On October 28, 2021, Committee of the Whole (COTW) reviewed the rezoning and development permit applications for 1737 Rockland. There was general consensus that this was reasonable and sensitive densification, however Council wanted the proposal to be brought a little closer to policy. The focus of comments revolved around changes to further respect neighbouring properties. To this end the following motion was passed:

A letter to Mayor and Council June 5, 2021 describes the many details of this project with respect to heritage designation, green building, project benefits, government policy, community and city engagement as well as landscape and building design. The purpose of *this* letter is to provide a review of the proposal and describe the changes made in response to Council’s motion of October 28, 2021.

2 Changes to Proposal

Building A Modifications

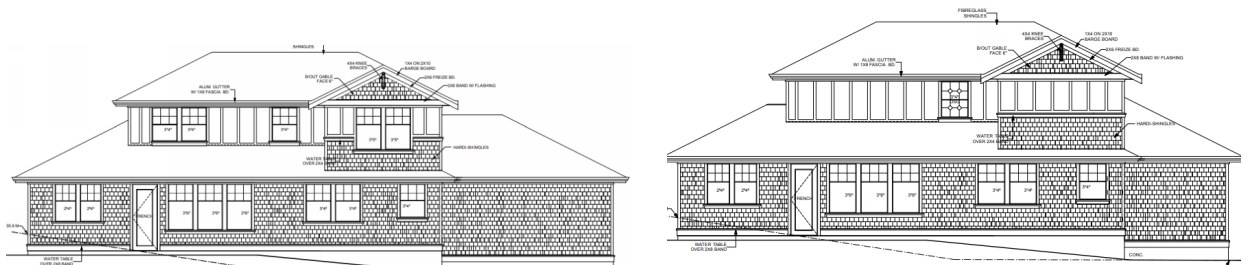
All upper bedroom windows had been removed from the rear (south), to eliminate any possible overlooks to the neighbour on Lyman Duff. The only window on this elevation is an obscured bathroom window.

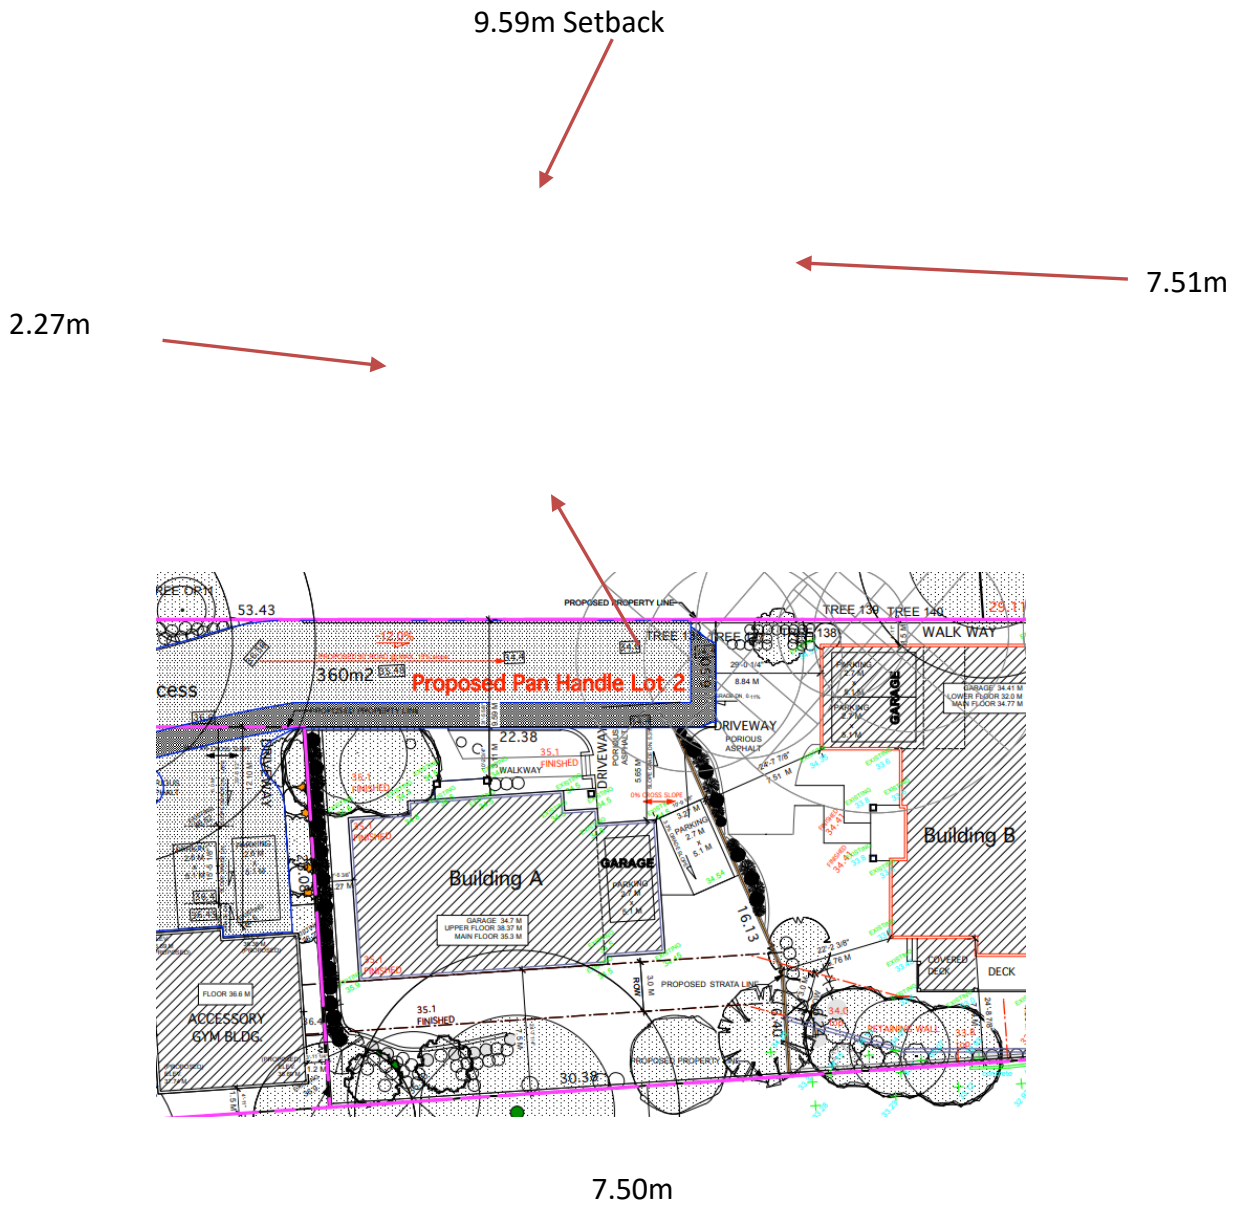
To help reduce visual impact the building height was reduced from 6.87m to 6.6m by changing the top floor ceiling height to 8'.

The panhandle zone calls for a single storey building, again in support of privacy. However, the size of the lot allows a second storey because there are sufficient setbacks (see below) to avoid privacy concerns. Note the second floor is stepped in significantly and is about half the size of the main floor, making this a 1 1/2 storey building.

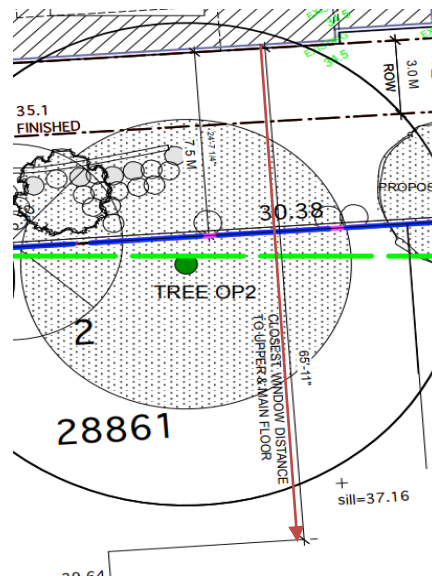
To further illustrate privacy protection, the distance from the proposed house to the neighbours closest window is almost 20m.

East Neighbour

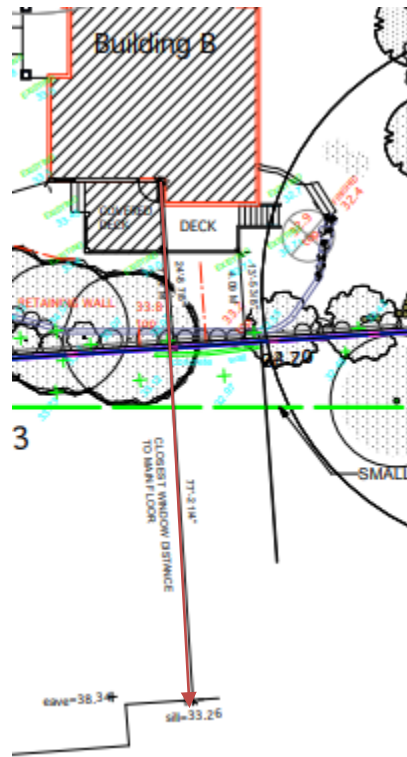
Building B was pulled to the west (moved 'forward') which increased the east (rear) setback from 5.0m to 7.5m, to align with policy. The actual distance between the buildings (to the east neighbour) is 11.8m.

Notably, the east elevation faces the side yard of our neighbour, and more specifically is adjacent their garage where there are very few windows. In addition to the increased setback the neighbour's rear yard and recreation area is further obscured by a large tree on their property.

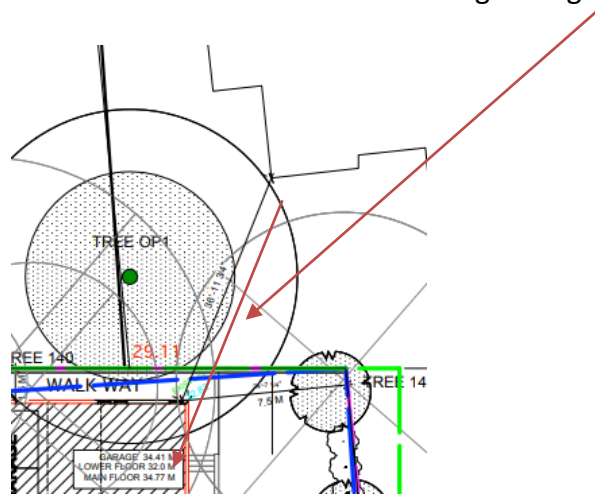
To bring the application closer to policy, Building B design was significantly modified to allow the south setback to now be 7.5m (to a habitable window). The actual distance between the buildings is 23.5m, or 19.4m from the deck.

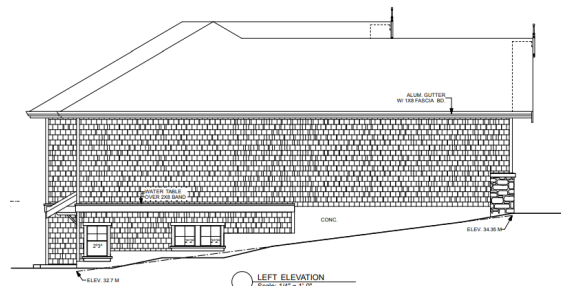
The north set back is 1.5m with the actual distance between buildings being 11.3m.

On the north elevation all upper windows were removed to eliminate overlooks. This side of building B is meant to be a simple pathway to the suite. There are no areas to recreate.
